E3641A-01

S E R V I C E N O T E

E3641A DC Power Supply

Serial Numbers: MY40001800 to MY40001950

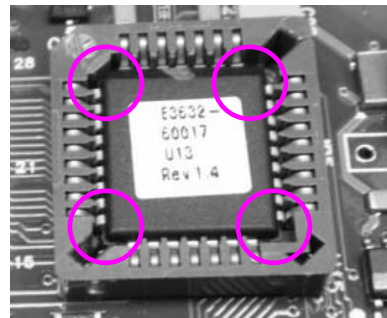
When the unit is power ON, the display went off immediately.

1. Upon turn on the power supply, if the symptoms are as follows:
 - a. Display light up and then become blank with fan running
 - b. Display light up and hang with fan running
2. Turn OFF the power supply.
3. Remove the existing EPROM and replace with a known good EPROM.
4. Refer to the reference designator of EPROM according to model:

5. Turn ON the unit again and see if the symptom disappears.
6. If the symptom still occurs, turn OFF the unit.
7. Return the unit to factory for Failure Analysis.
